Evaluation of Construction and Plugging Procedures for Injection Well 357-7R at the CTV-Elk Hills Monterey Formation A1-A2 Class VI Project

This well construction and plugging evaluation report for the proposed Carbon TerraVault (CTV)-Elk Hills Class VI geologic sequestration (GS) project summarizes EPA's evaluation of several related activities associated with construction and plugging of the 357-7R injection well to inject CO₂ into the Monterey Formation A1-A2 Sands. These activities are described in the permit application narrative, and Attachment D to the permit application dated August 30, 2021, and an updated version of Attachment G (a file entitled Attachment G—Final), submitted on December 2, 2021. This review also identifies preliminary questions for the applicant. (Note that the permit application contains common information that applies to both injection wells planned for the project. Therefore, there is some repetition between this evaluation and EPA's evaluation of the attachments relevant to Well 355-7R. This is necessary to provide a complete evaluation for each Class VI permit record.)

Figure 1: Injection Well 357-7R casing diagram (Attachment G)

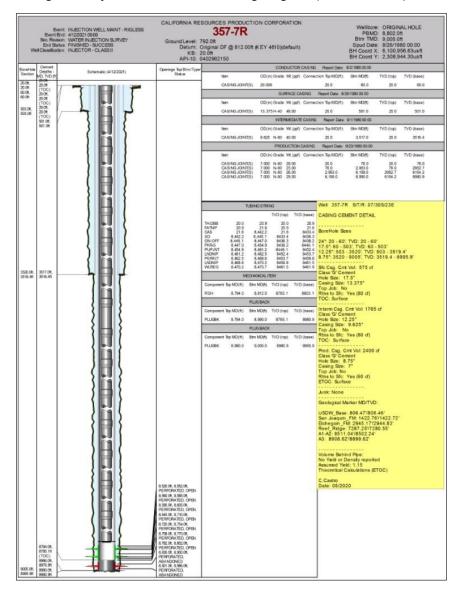
Relevant geologic formation tops were noted in Figure 1 of Attachment G. The figure shows that the Base of the USDW is approximately 806 ft. TVD (true vertical depth), which is behind both the long string and intermediate casing. The surface casing is set to a depth of 501 feet; however, the average depth of the Tulare Formation (Upper and Lower) within the AoR is 600-2,500 ft (as reported on pg. 31 of the Narrative). EPA is requesting clarification of the depth of the Upper Tulare Formation (the lowermost USDW) in its questions on the geologic narrative, and CTV's response to this question will help confirm whether the surface casing is sufficiently deep to protect the lowermost USDW in accordance with 40 CFR 146.86(a)(1). Based on the aquifer exemption record of decision for the Elk Hills Oil Field, the Upper Tulare is shallower than 400 feet.

(confining zone), Monterey Formation A1-A2 (reservoir), and Monterey Formation A3 are located at depths of 7,281 ft TVD, 8,502 ft TVD, and 8,900 ft TVD, respectively; these three formations will be behind the long string casing. The depth of the Etchegoin Formation on the well diagram is consistent with information in the permit application narrative, and the depth of the Monterey Formation A1-A2 Sands differs from the depth reported on Figure 13 of the permit application narrative of 8,403 ft – 9,598 ft TVD.

The perforations for Well 357-7R are shown at depths of 8,782 to 8,830 feet. The perforations are also described in the AoR and Corrective Action Plan; however, they are presented in depth relative to mean sea level, so confirmation that the depths are consistent is not possible.

- Please include relevant information from the narrative (Attachment A) about the construction of the well into Attachment G for completeness.
- In Figure 1 of Attachment G (Well 357-7R casing diagram), the top of cement for the existing bottom-hole plug is listed at 8,794 ft MD / 8,785 ft TVD while the base of the open perforated interval is 8,802 ft. Please revise Figure 1 to correct this inconsistency.

- Please label the well diagram to indicate that the well is a Class VI (i.e., not Class II) well.
- Please explain how the injection well's design will mitigate potential shallow compression resulting from land subsidence and comply with the requirement to cement to the surface.

Plug #1 (bottom-hole cement plug) will cover all perforations and will extend at least 100 ft. above the uppermost perforations. However, based on Figure 1 of Attachment G, the uppermost perforations occur at 8,520 ft, resulting in the top of the plug occurring 93 ft above the uppermost perforation. The cement volume will need to be revised for Plug #1 to ensure at least 100 ft of cement coverage above the uppermost perforation.
